ACOUSONDE™ ATTITUDE/HEADING AXIS CONVENTION UPDATE

Model B003A and B003B

Firmware version 2.0.14, PalmOS client software version 2.0.3
January 2011

William C. Burgess

Figure 1.   Acousonde accelerometer and compass axes as configured in 2011.

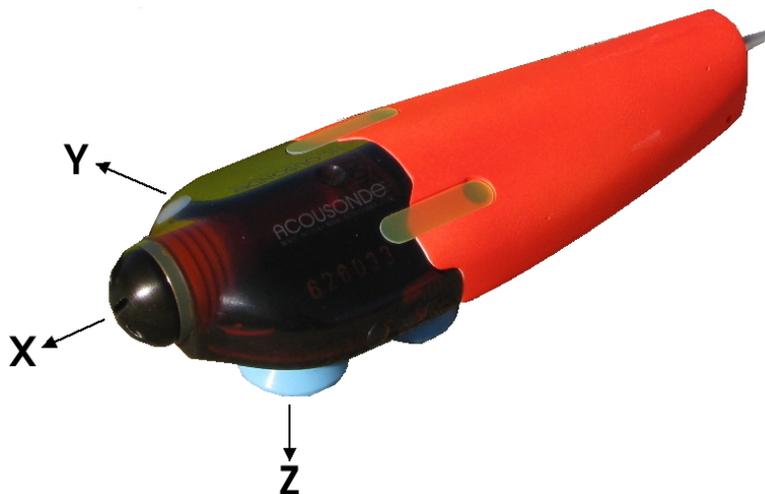
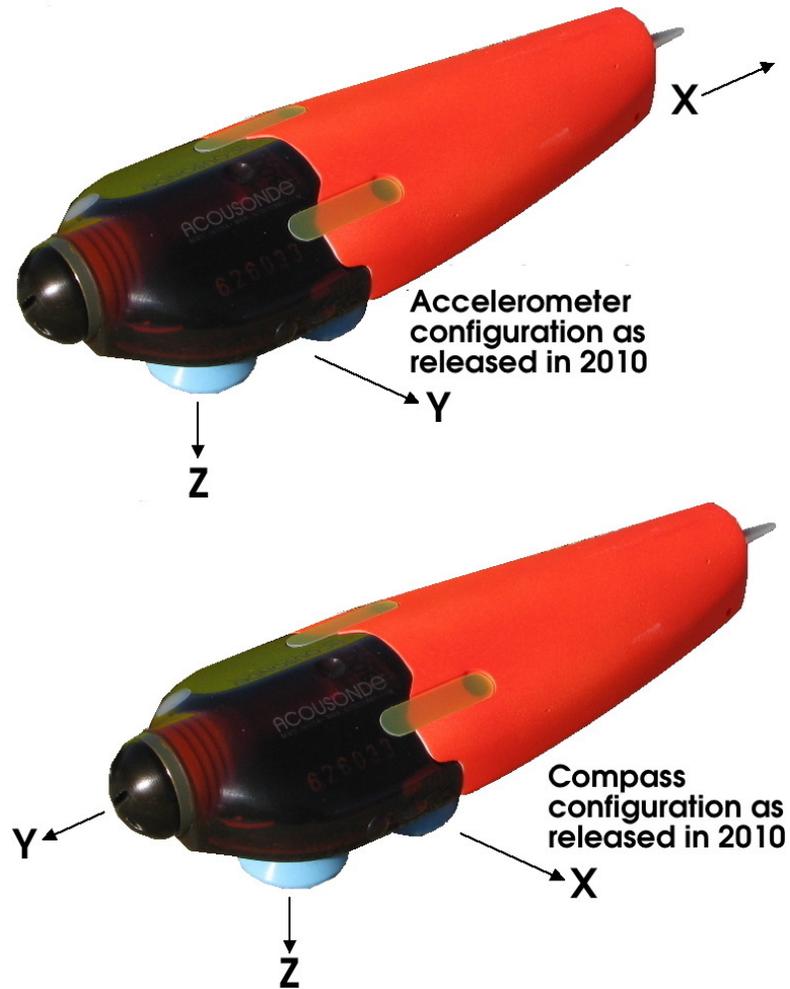
Marine navigation systems typically adopt the "north, east, down" reference-frame convention to represent attitude and compass heading. Acousonde units released in 2011 and after use axis conventions optimally compatible with this standard (Figure 1).

Alignment of the compass X, Y, or Z axes towards north yields positive samples in the corresponding channel. Samples from the X channel will be near maximum when the Acousonde points north; from the Y channel when the Acousonde points west; and from the Z channel when the Acousonde's bottom points north.

Accelerometer X, Y, and Z* channels yield positive samples when the device is accelerated in the corresponding direction. Since gravity is equivalent to acceleration away from the Earth, it will induce positive samples on X when the Acousonde is pointed up; on Y when the Acousonde is positioned horizontally on its left side (i.e. 90° left roll); and on Z when the Acousonde is upside down.

Acousonde units released in 2010 and before use alternate axis definitions (Figure 2). Acoustimetrics recommends that all pre-2011 units be updated for maximum compatibility. Updating may be less important for users who foresee no kinematic applications.

Figure 2. **Acousonde accelerometer and compass axes as configured prior to 2011.** Units released in 2010 or before that have not been updated use this axis configuration, now deprecated in favor of that shown in Figure 1.
